CITY OF ALBUQUERQUE

Re: Murphy's Express, 2707 Carlisle Blvd. NE,

Request for Permanent C.O. –Accepted

Re: Murphy Express – 2707 Carlisle Blvd NE – Grading and Drainage Certification

SITE PLAN FOR BUILDING PERMIT LOT 1, BLOCK A-1-A1, AMERICAN SQUARE

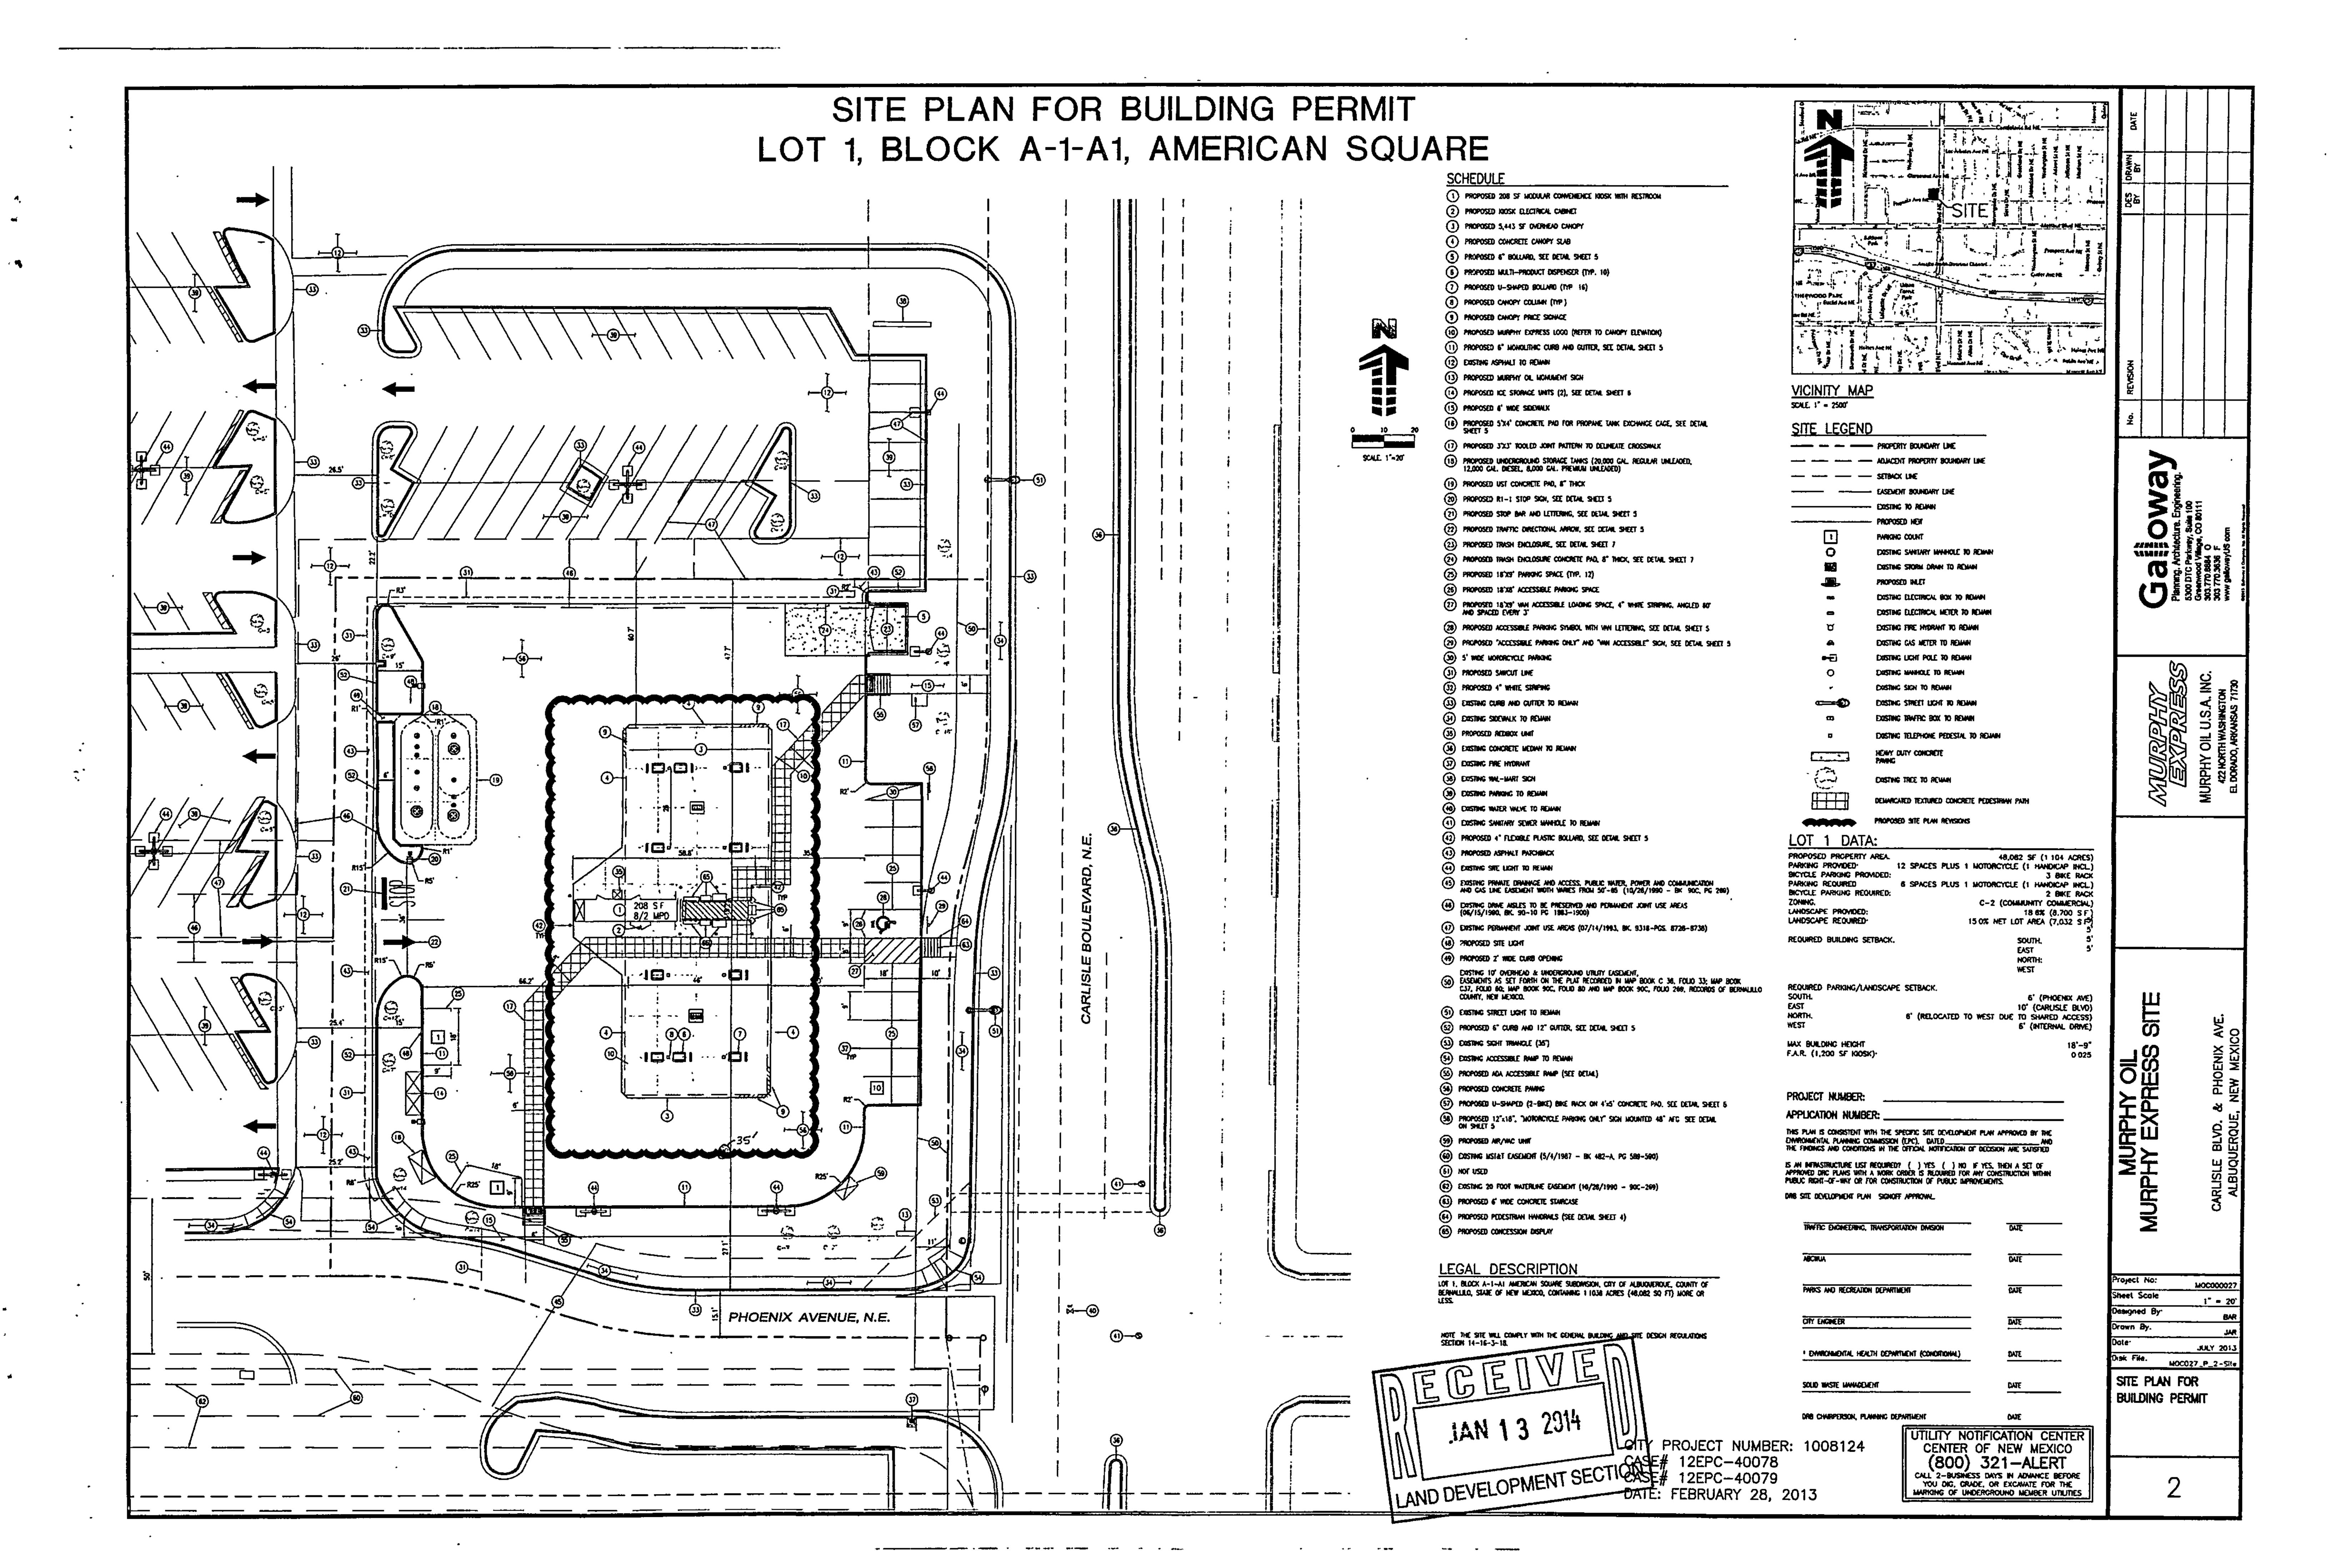
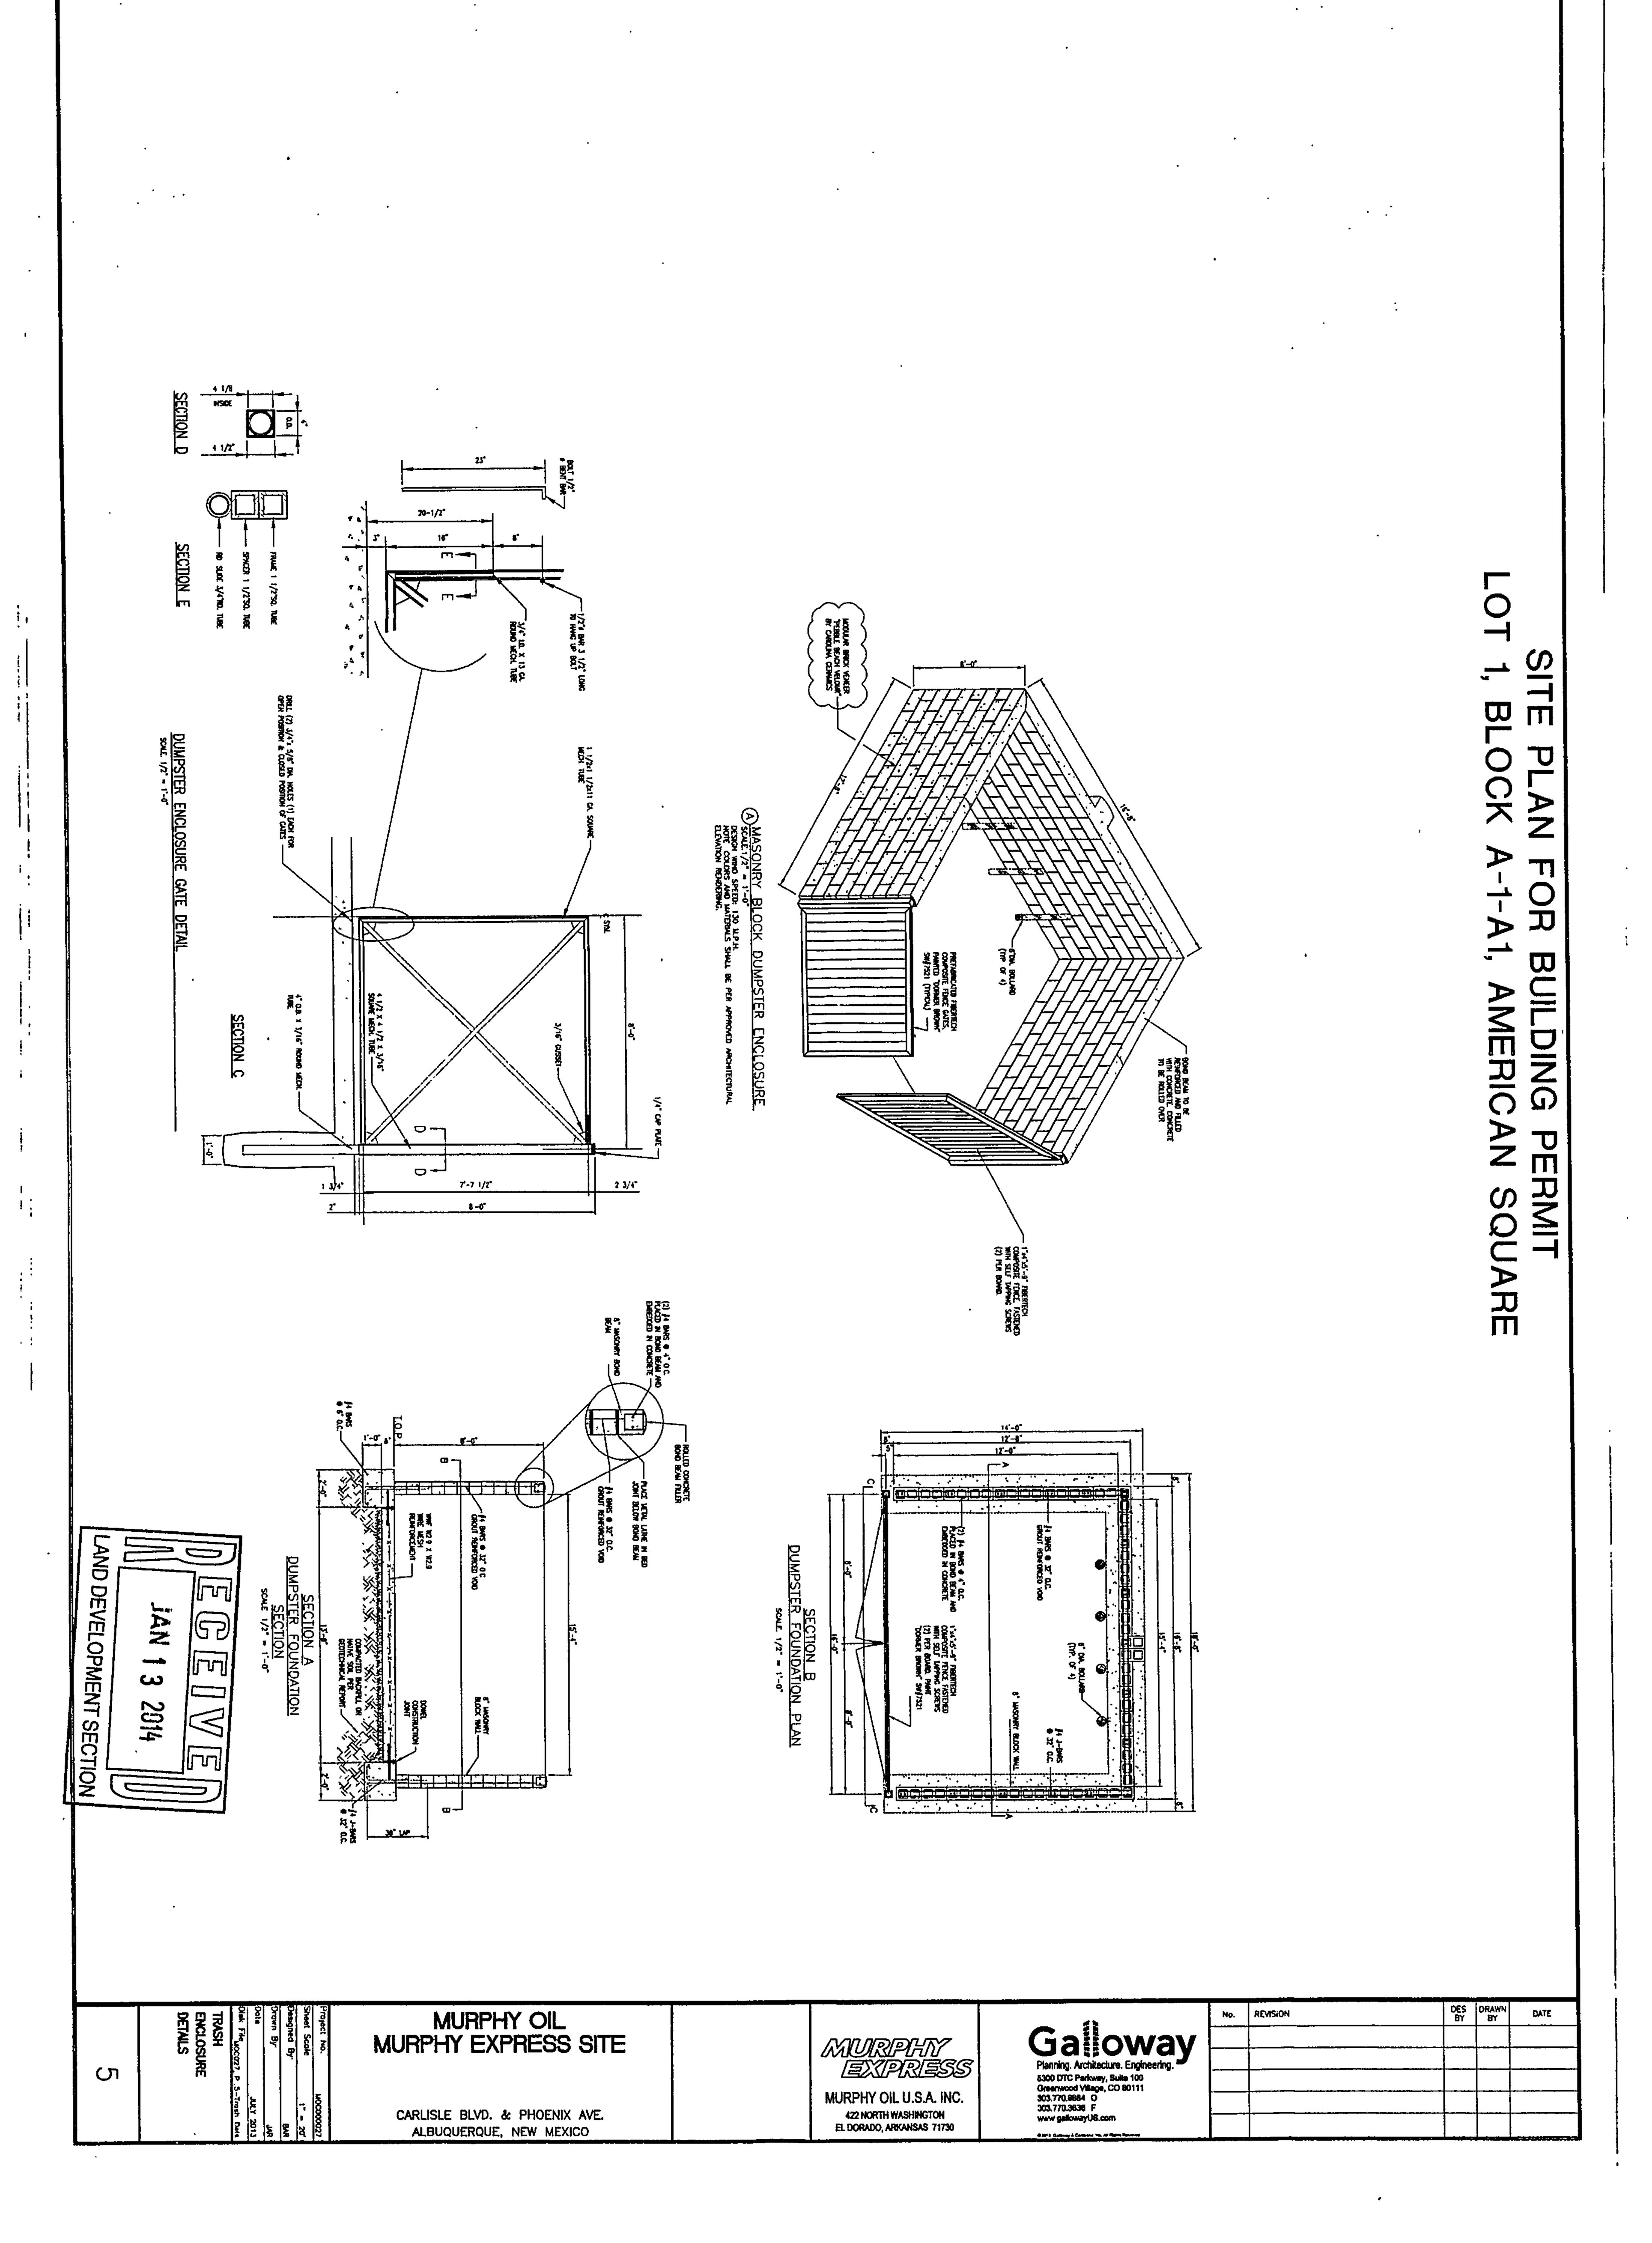
It appears that we've run into an issue with the coolers and sales racks being proposed in front of the cashier window. They are a lot larger than we had anticipated. The largest cooler is 3'-7 1/2"W x 9'-7"L. As a result, it will encroach into the 6' wide walkway that we have constructed on the south side of the kiosk.

I have a two part question. First, this project went through EPC and DRB and the comments that came back in regards to accessible pathways were that we needed a 6' accessible path from Carlisle to the building and a 6' wide accessible path from the ADA parking to the building. It seems to me that we are meeting both of those criteria even without the walk that is being encroached upon south of the building. This path leads to a private side walk on the south side of the property. I took this project over toward the end of the DRB approval process, so I don't know why the walk to the south side of the property was added in the first place. It seems to be in excess of what the DRB comments recommended, so I wanted to know if it is even needed?

The second part to my question, is, if this walk is required by the City, does it need to be 6' in width? Looking through the TCL criteria, it appears that the city standard accessible walkway width is 4' instead of 6'.

I have attached a sketch of what we would like to propose as a fix and I've also attached the DRB comments that we received. Please give me a call to discuss when you get a chance. At this point, I'm trying to figure out what options we have and since we are trying to wrap these projects up as soon as possible, time is of the essence.
